Historic Preservation Board

Wednesday, August 2, 2023 at 5:00 PM
Via Zoom

STAFF MEMORANDUM HISTORIC PRESERVATION PROGRAM PLANNING AND URBAN DEVELOPMENT

Construct new townhouses and large mixed-use building (Block 4) on site partially within and adjacent to the Portland Company Historic District.

Summary of April 5th, 2023, HP Board Workshop items that Design Team has advanced in preparation of May 15, 2023 materials.

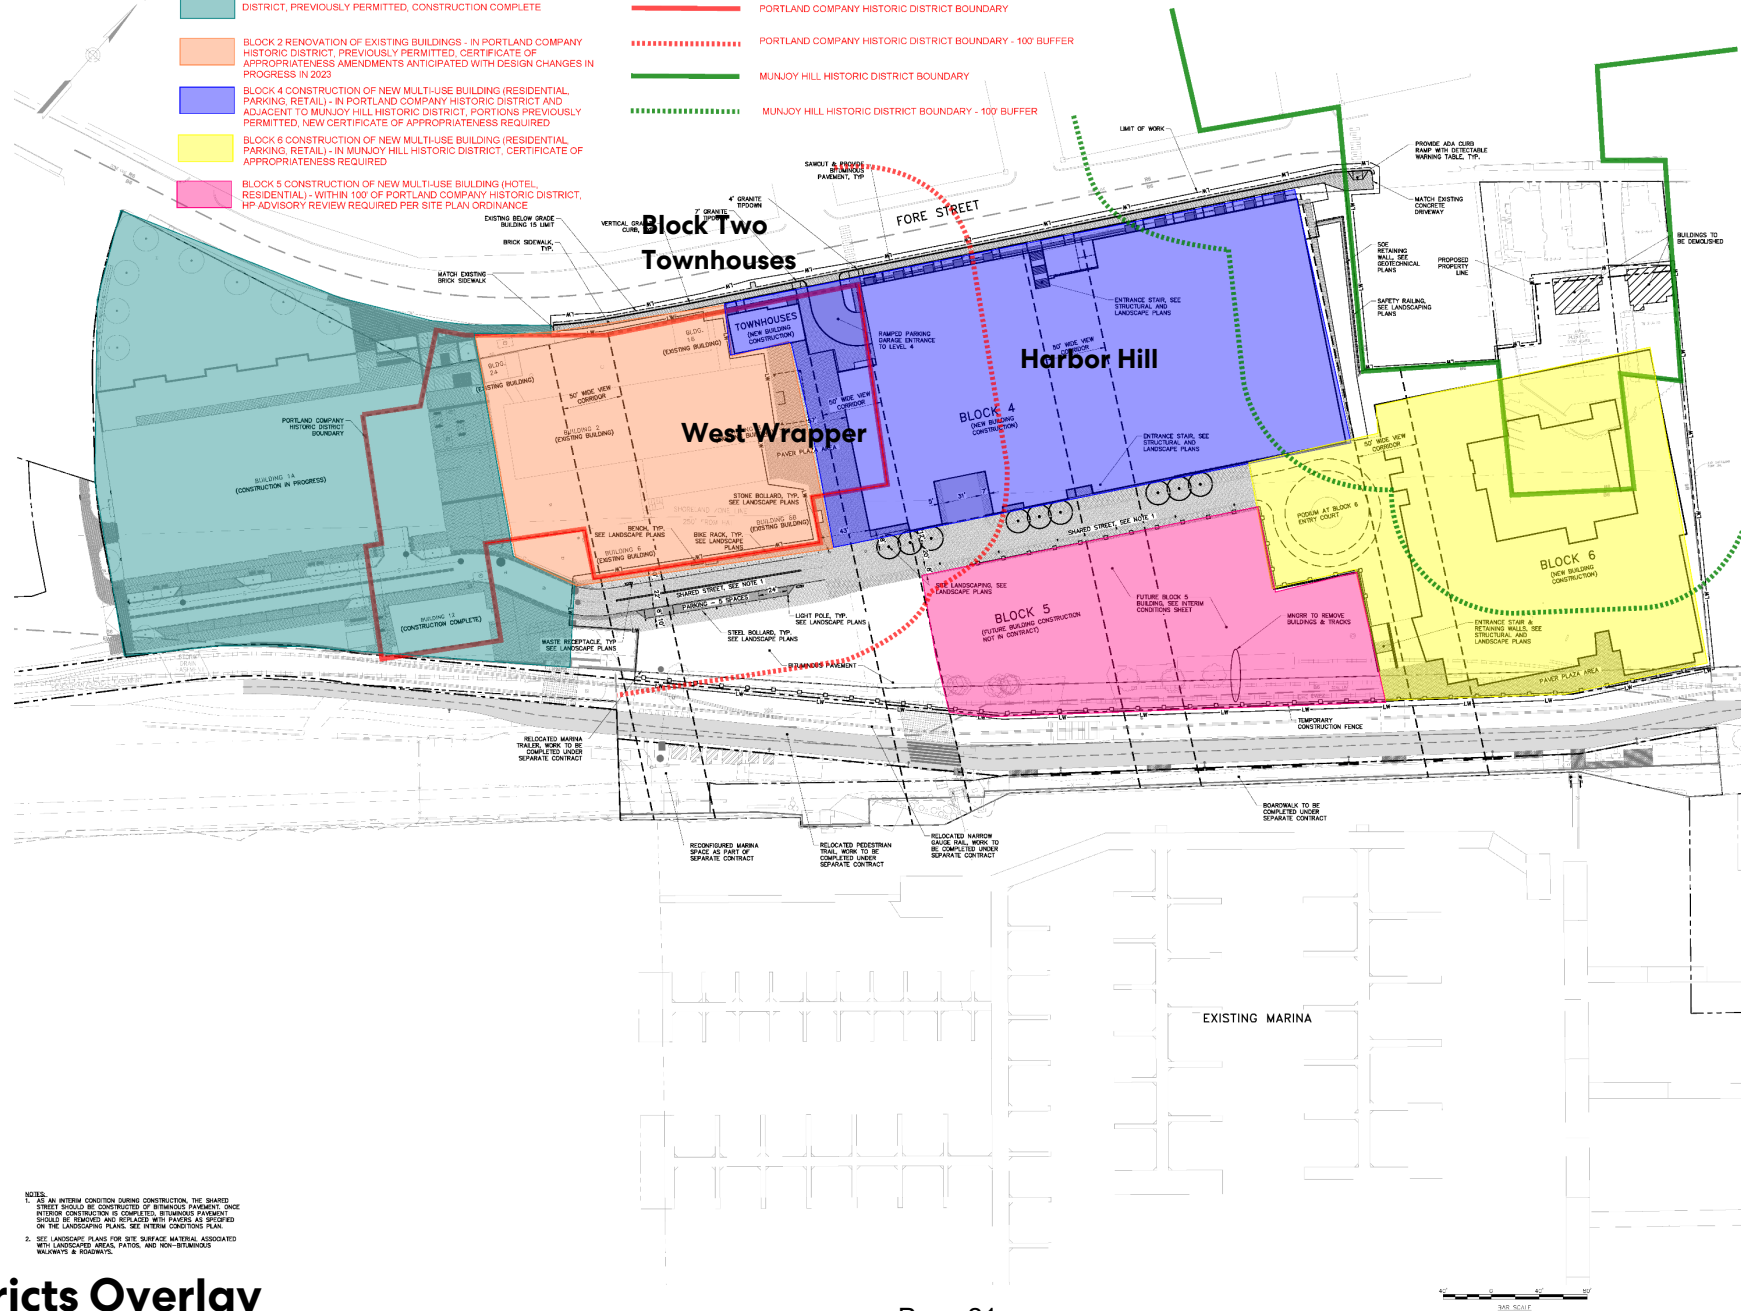
- **Explore ways to diminish perceived height of B2 THs & core elements facing within the Portland Company HD.**
[Now expressing a distinct ground floor 'band' for B2 townhouses, now in keeping with the materiality of the rest of the new architecture](#)

- **Study scale of West wrapper & fronting space of John Poor Crossing with context and scale of existing campus**
[Example of similarity of scale in space, comparing public space volume between John Poor Crossing and the Sun Life / Grand Stair plaza.](#)
[Slide 16: comparing scale of existing historic plazas as terminated in space of West wrapper across John Poor Crossing.](#)

- **Provide further detail on pedestrian entrance / arrival to Portland Company from Fore Street, including presence of B2 Townhomes along street**
[Composition of Fore Street and B2 Townhouses framing the view corridor at Waterville Street as entry for pedestrian / visitor access to core at parking entry / lookout over Historic District and marina below.](#)

● **YS2A**

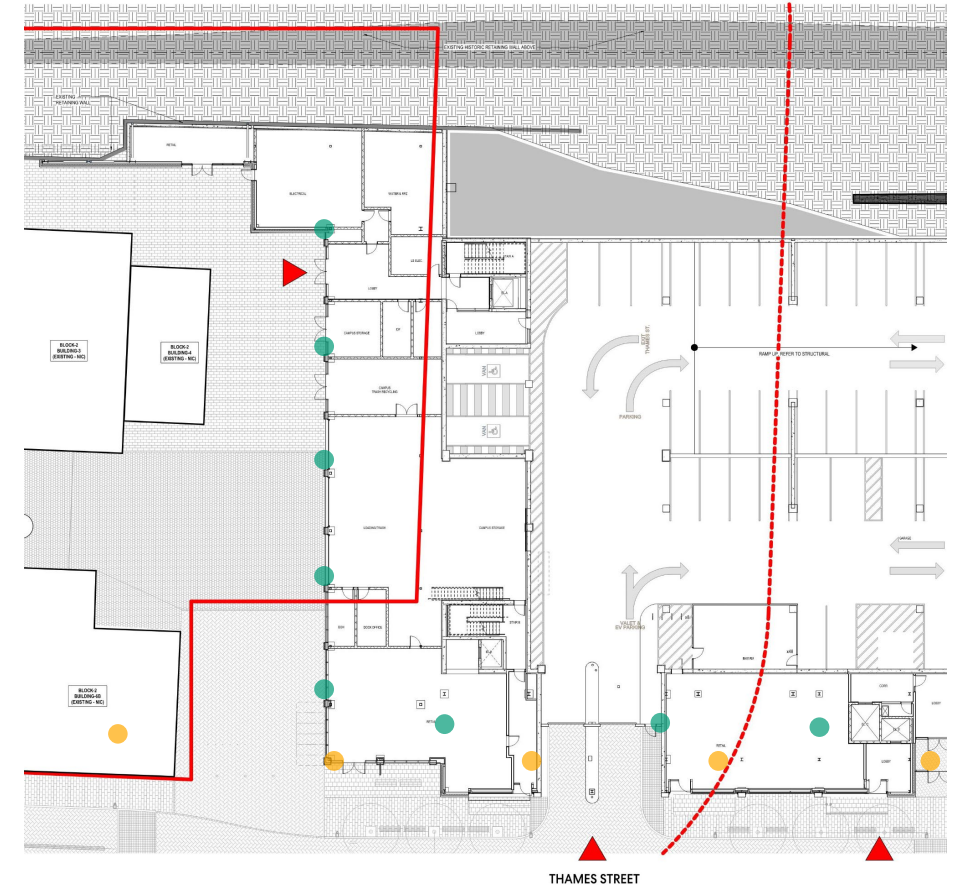
- **Provide a comparable level of detail for driveway podium and Block 2 Townhouses**
[New Slide 36 added to include requested drawings.](#)
- **Sheet 41: Where on the building will the YS2A be mounted? Will they be casting up or down light?**
[Slide 42 \(Previous 41\) West Wrapper elevation added locating light fixtures and noting elevation 14'-6" for YS2A fixtures casting light down.](#)

6B ELEVATION - 7TH FLOOR TERRACE ENTRY

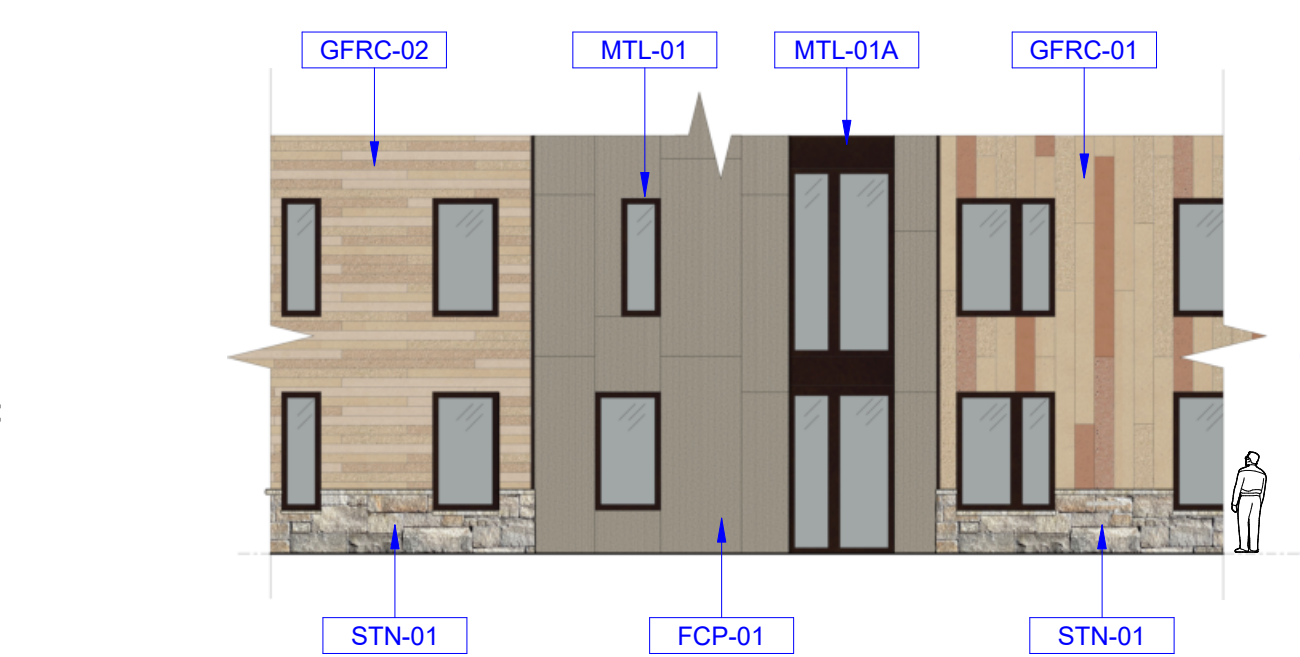
- Details 6B and 6A were added to A201
 - 6A EXTERIOR MATERIAL APPLICATION RENDERING is provided to show a more photo realistic view of the primary façade materials adjacent to one another v. the “construction document hatching” as shown in the overall elevations on A200 & A201

2A EXTERIOR WALL TYPES

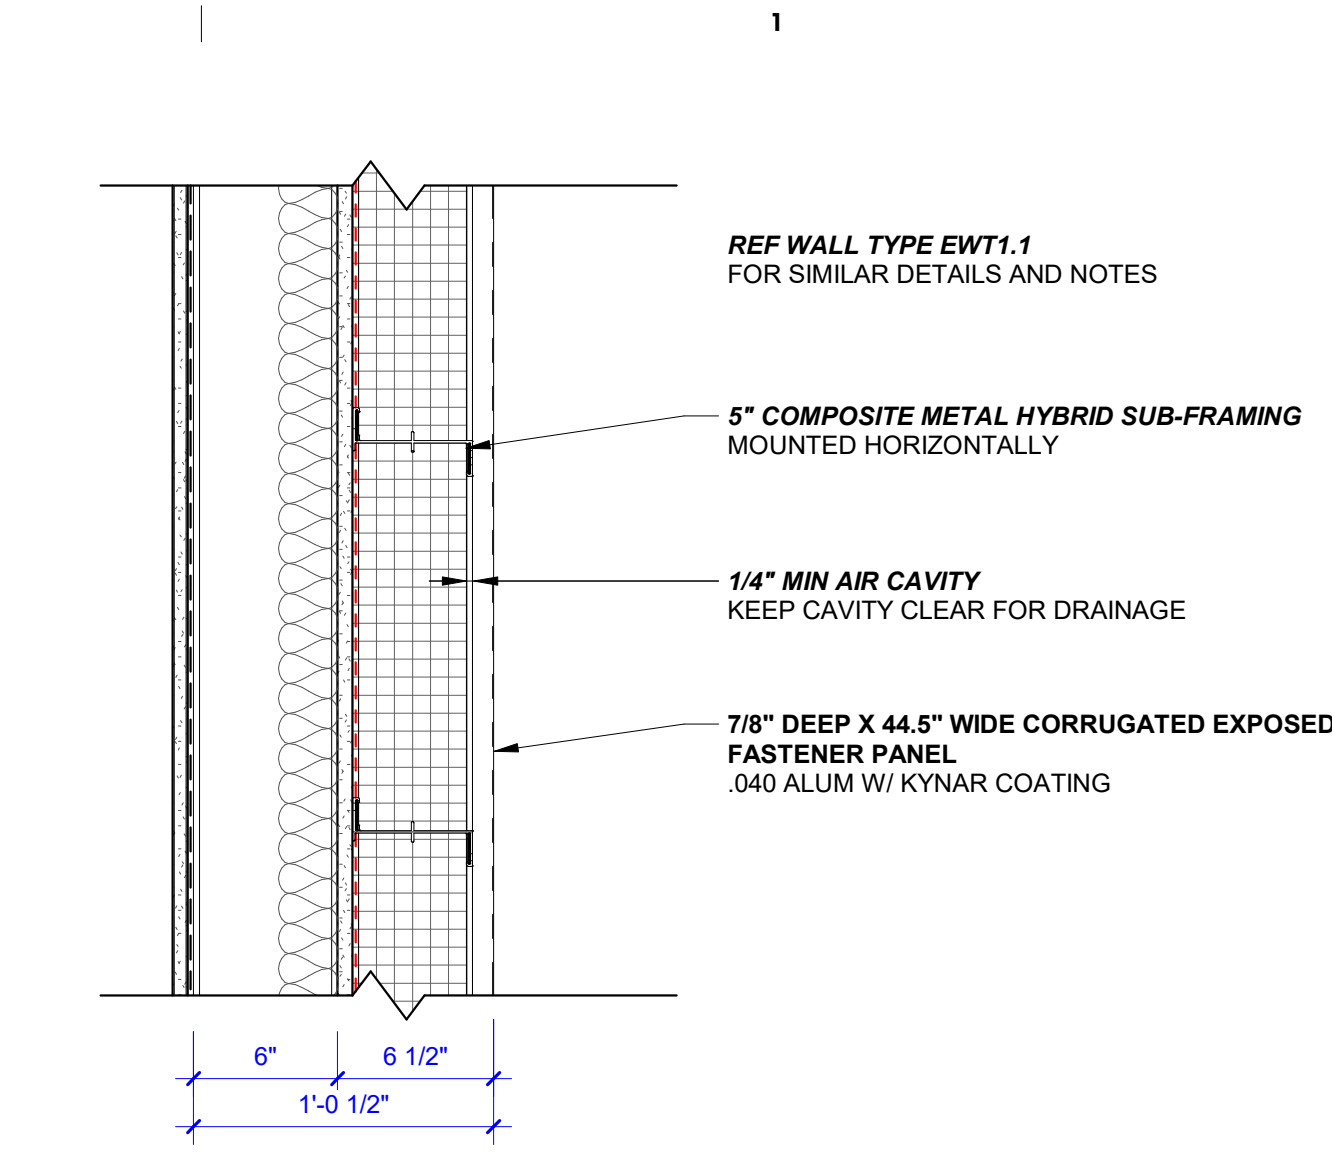
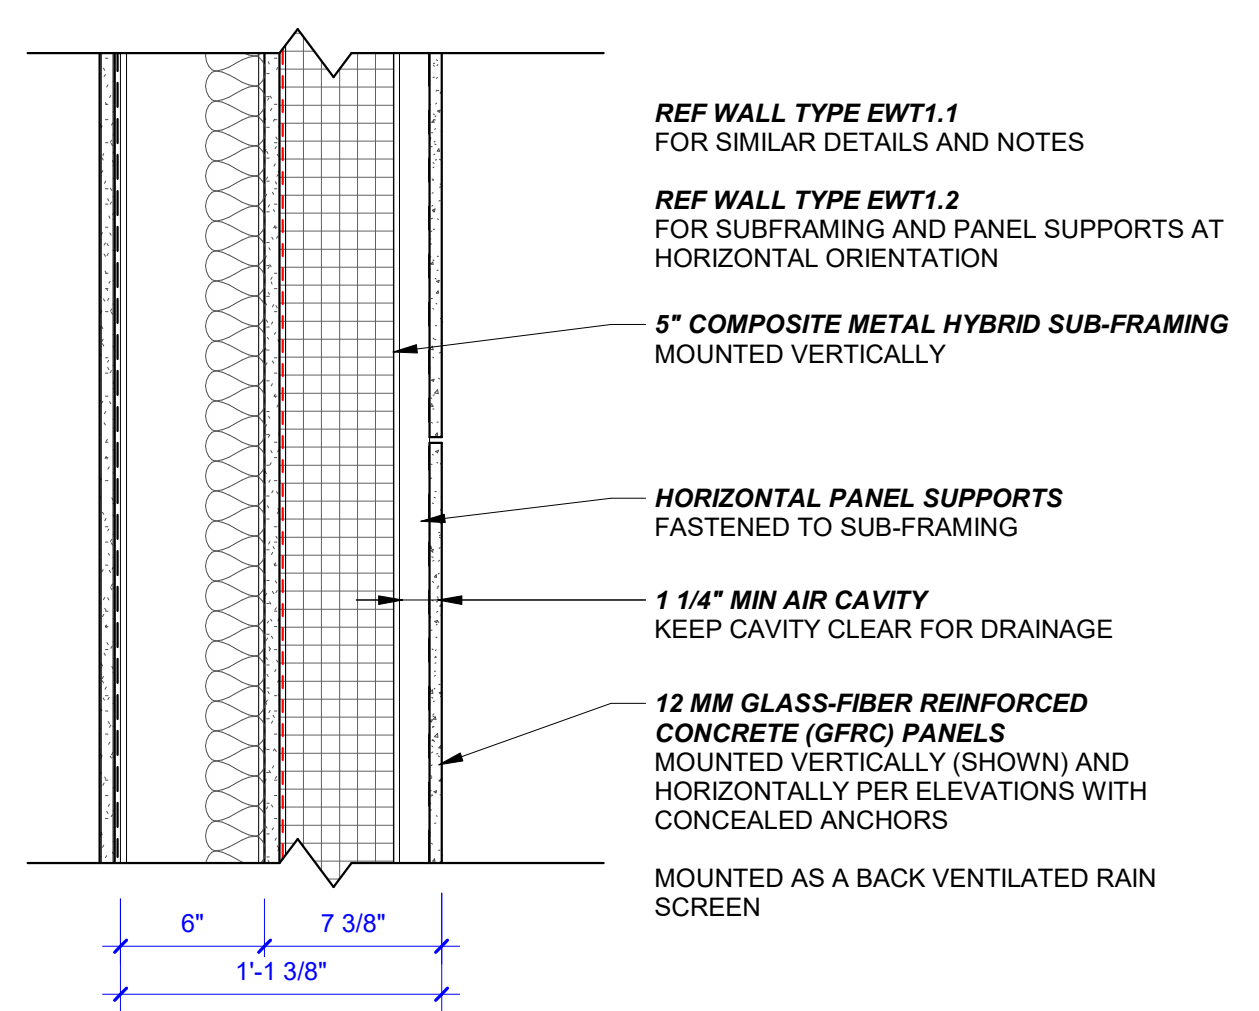
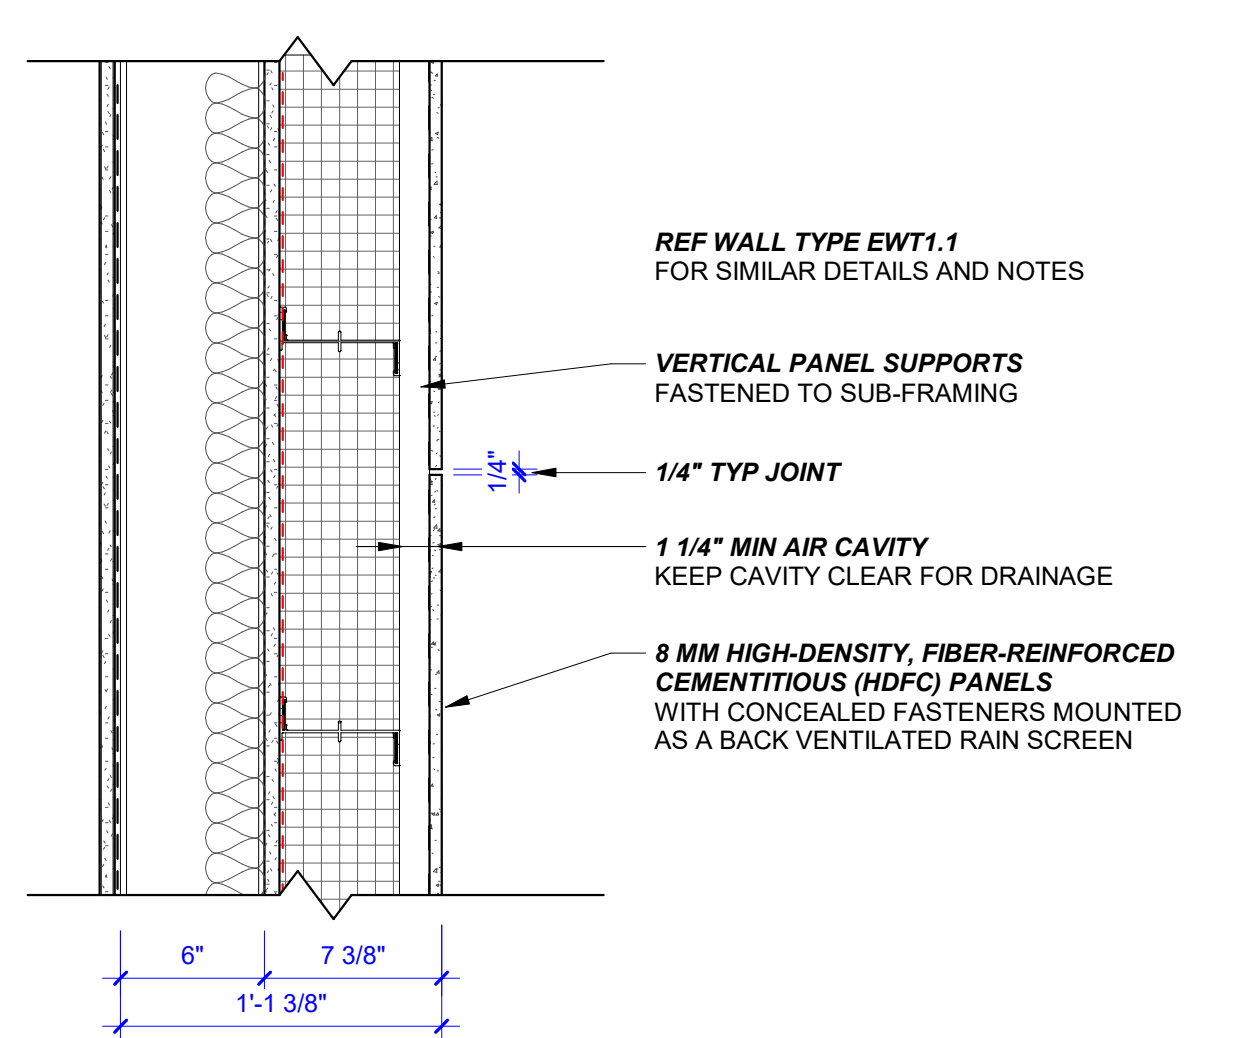
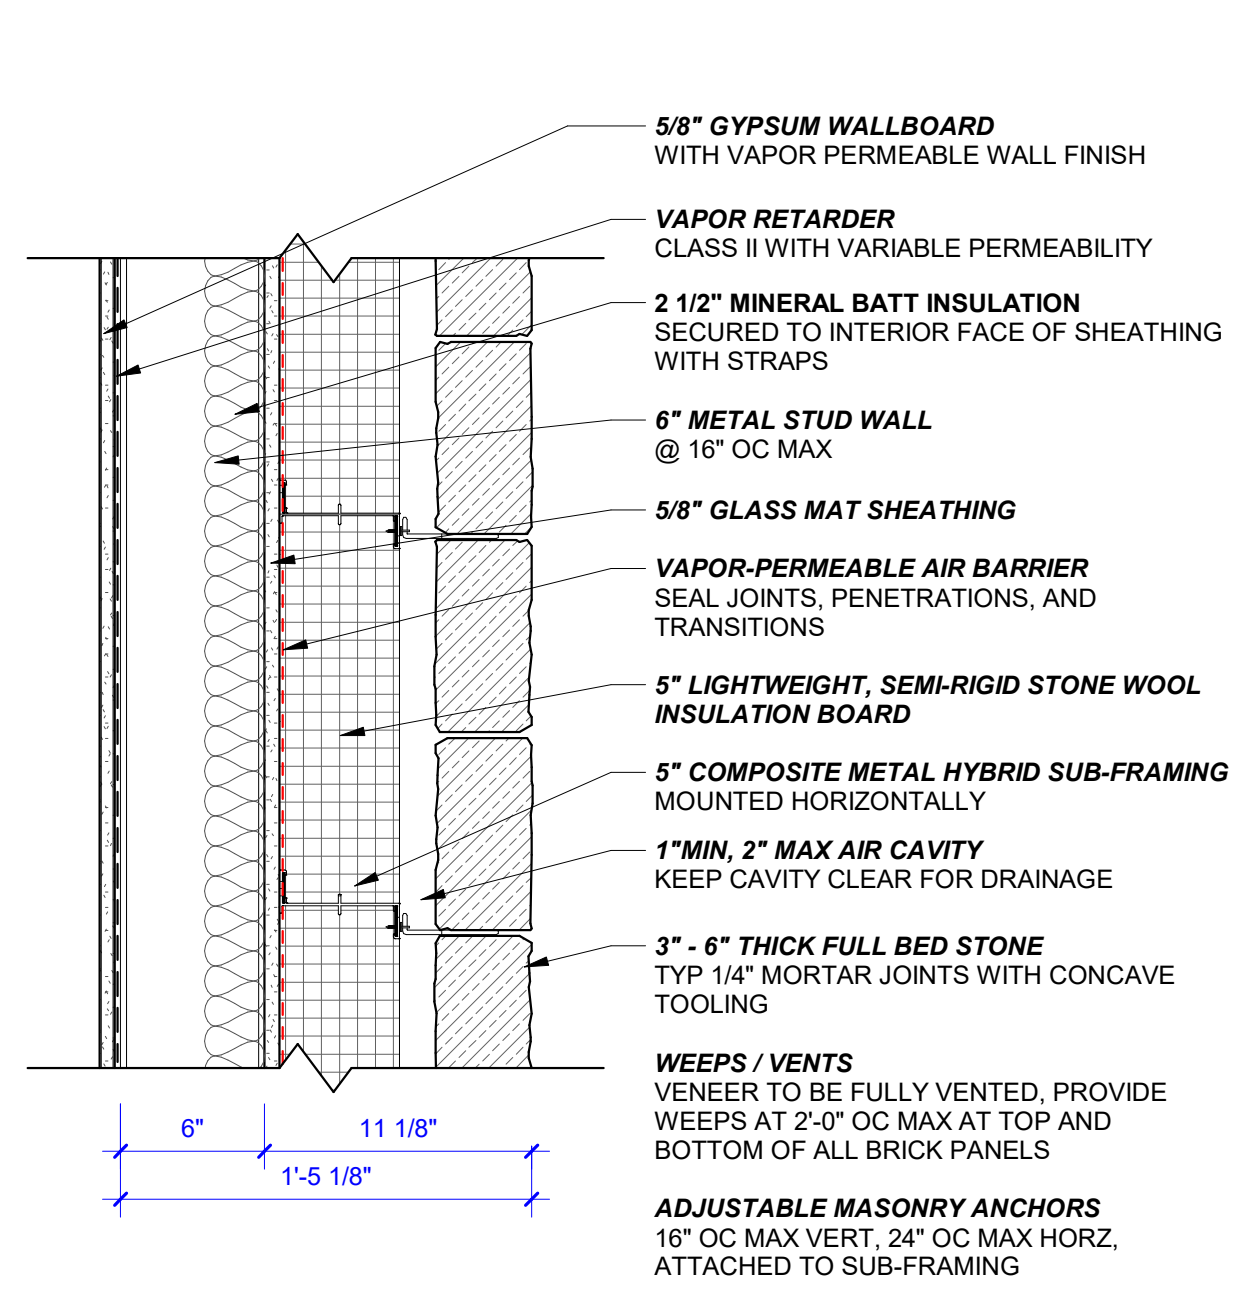
- Sheet A301 was added to provide exterior envelop detailing
 - 2A EXTERIOR WALL TYPES shows each of the (3) primary finish materials STN, GFRC, & FCP and the rain screen attachment method and typical wall size at each. The below grade application of metal panel is also provided.
